# 802.1CB-2017/Cor1

Supporting material for maintenance item #343  
implementation

Christophe Mangin

November plenary session, Nov 12 2024

Figure C-10—Protocol interworking

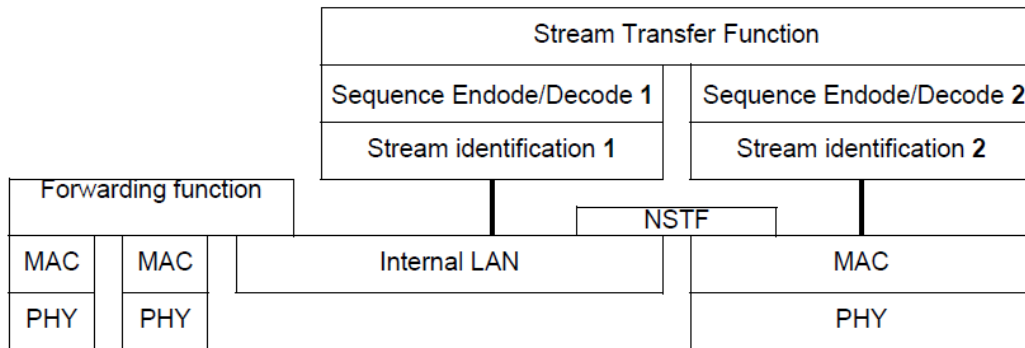
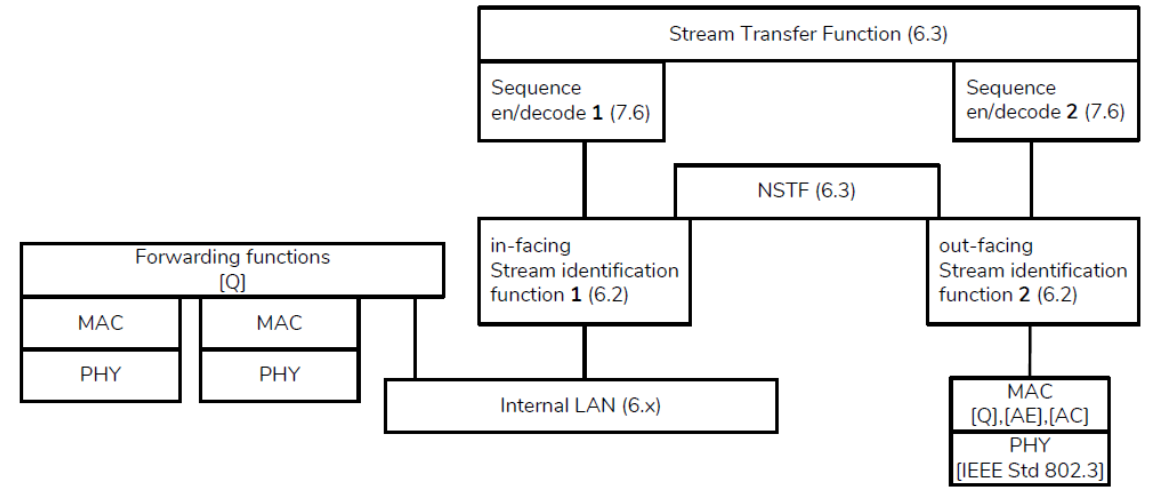
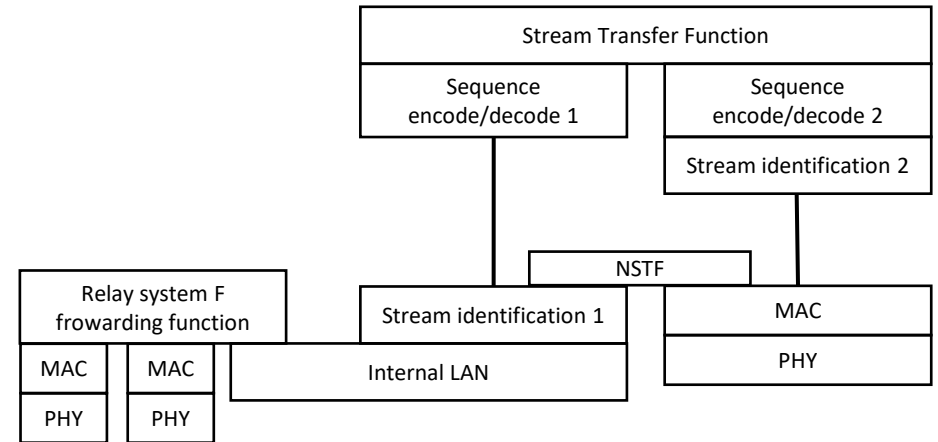
- This should be consistent with clause 8

Figure C-12—Protocol stacks for Systems B and G in Figure C-11

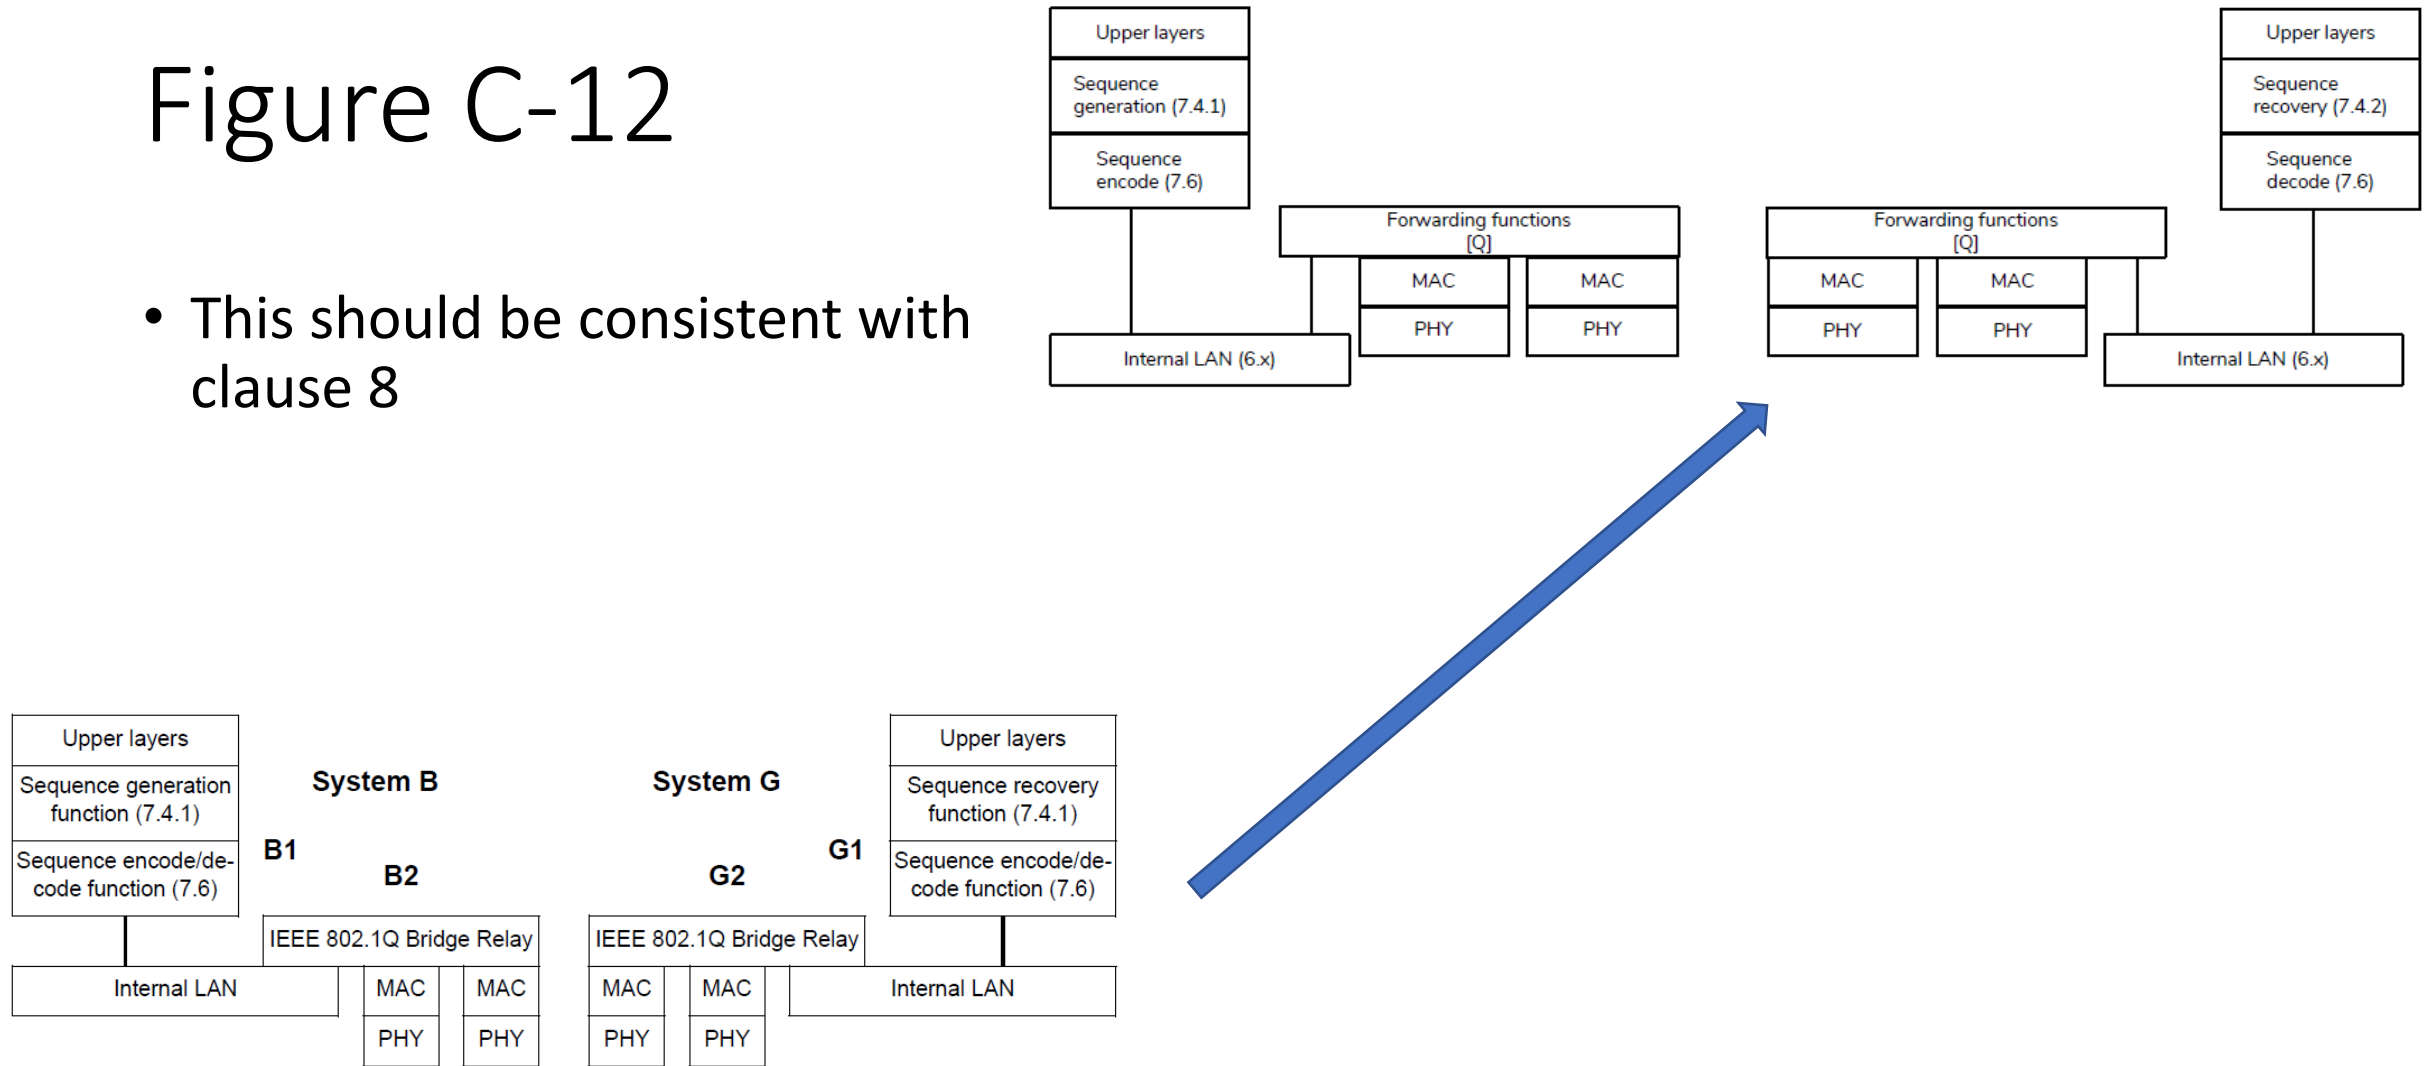
- This should be consistent with clause 8
